Urban Design Consultation

Proposal: Discharge of conditions 2 (Materials - main development site), 4, (Architectural Details - main development site), 7 (Parking bollards), 8 (Hard Landscaping), 9 (Road details), 12 (Bin Collection Points), 13 (Car Parking Demarcation), 16 (Substation) for 23/00369/REM	**Location: Land North Of 16 The Bank Somersham**
Case Officer: Kevin Simpson	**Application: 24/80435/COND**

Facing bricks (left to right) – 'Village Harvest Buff', 'Village Oatmeal Buff', and 'Clumber Red Mixture':

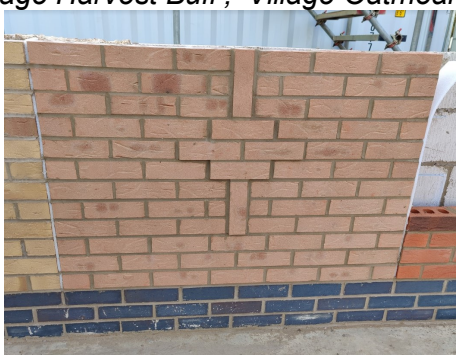
The distribution of facing bricks shown on the submitted Charter Plan Rev N largely accords with the approved drawing (Rev K), however concern was raised regarding the Village Oatmeal Buff which appeared overly pink on site – as such the distribution of facing bricks has been amended to reduce the number of units in Oatmeal Buff.

The Charter Plan Rev N now proposes the following changes to the distribution of materials:

- Plots 17-19 brick colour changed to Oatmeal Buff,
- Plots 4, 47 -50 (47 garage included) changed to Clumber Red Multi and slate grey roof,
- Plots 6 (and double garage between Plots 5 and 6), 7, 29, 45, 73-76, 85-86, 88-89, 116-117, 125-127 changed to Village Harvest Buff and red roof tiles

These changes are accepatble and are as discussed with Georgia McCrae (Allison Homes) on site on the 28/11/2024.
